SUBJECT: ISSUANCE OF AMENDMENT FOR THE WASHINGTON PUBLIC POWER SUPPLY
SYSTEM NUCLEAR PROJECT NO. 2 (TAC NO. M84767)

The Commission has issued the enclosed Amendment No. 138 to the Facility Operating License No. NPF-21 for WPPSS Nuclear Project No. 2. The amendment consists of changes to the Technical Specifications (TS) in response to your application dated September 2, 1992.

AMENDMENT NO. 138 TO FACILITY OPERATING LICENSE NO. NPF-21

SAFETY EVALUATION BY THE OFFICE OF NUCLEAR REACTOR REGULATION
RELATED TO AMENDMENT NO. 138 TO FACILITY OPERATING LICENSE NO. NPF-21

Figure 3.1.5-2

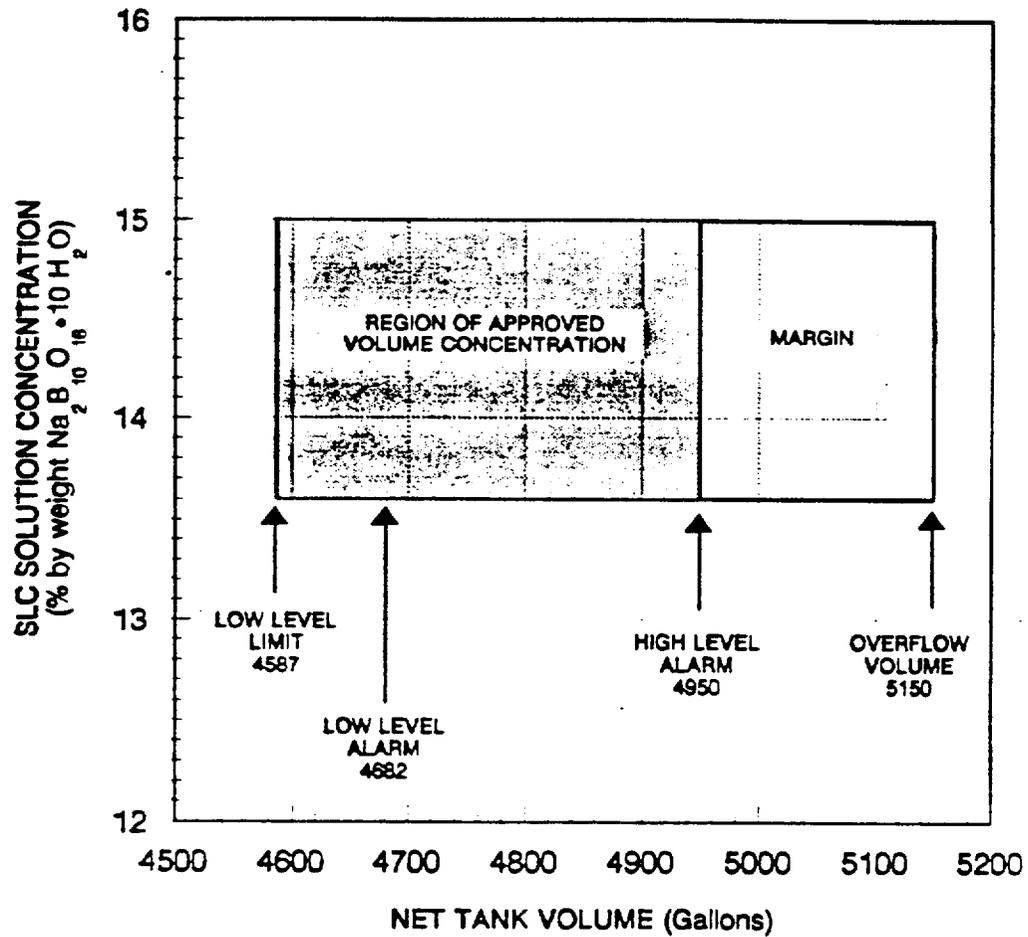
The amendment revises Figure 3.1.5-2, "Sodium Pentaborate Tank, Volume Vs. Concentration Requirements," to reflect the actual low-volume-alarm and low-limit values for the standby liquid control tank.

In its letter dated September 2, 1992, the Washington Public Power Supply System (WPPSS or the licensee) proposed that Appendix A of Facility Operating License NPF-21 be amended to revise the WPPSS Nuclear Project No. 2 Technical Specifications (TS). The proposed change would revise Figure 3.1.5-2, "Sodium Pentaborate Tank, Volume Vs. Concentration Requirements," to reflect the actual low-volume-alarm and low-limit values for the standby liquid control (SLC) tank.

The SLC system is designed to provide shutdown capability without control rod movement. The SLC system consists of the sodium pentaborate solution storage tank, two pumps, and piping and valves to transfer borated water from the tank to the reactor pressure vessel. Figure 3.1.5-2 provides the limits of solution and volume necessary to ensure that the SLC system is capable of fulfilling the system design function. The current figure indicates a low-level alarm at 4587 gallons, which is also the low limit for the tank volume. The licensee has determined that an alarm at the low limit is not a prudent design, as receiving an alarm at that level would not allow for corrective actions before violating the TS. The level at which the alarm is actually set for is 4682 gallons. Therefore, the licensee proposes to revise the figure to indicate a low-level alarm at 4682 gallons.

Section 50.62 of Title 10 of the Code of Federal Regulations specifies that for anticipated transients without scram mitigation, the SLC system shall have the capability in flowrate, B¹⁰ enrichment, and boron concentration such that, when accounting for reactor pressure vessel volume, an equivalent injection rate of 86 gallons per minute of 13 weight sodium pentaborate decahydrate solution at the natural B¹⁰ enrichment can be attained. Operation within the limits of Figure 3.1.5-2 ensures compliance with these requirements. The revised low-level alarm provides adequate margin to take corrective action before the low-level limit of 4587 gallons is exceeded.

This change does not affect the operation of the SLC system, but simply revises the TS to be consistent with the current operating practice and design basis. This change is conservative in that the low-level alarm point has been increased. Therefore, the change is acceptable.
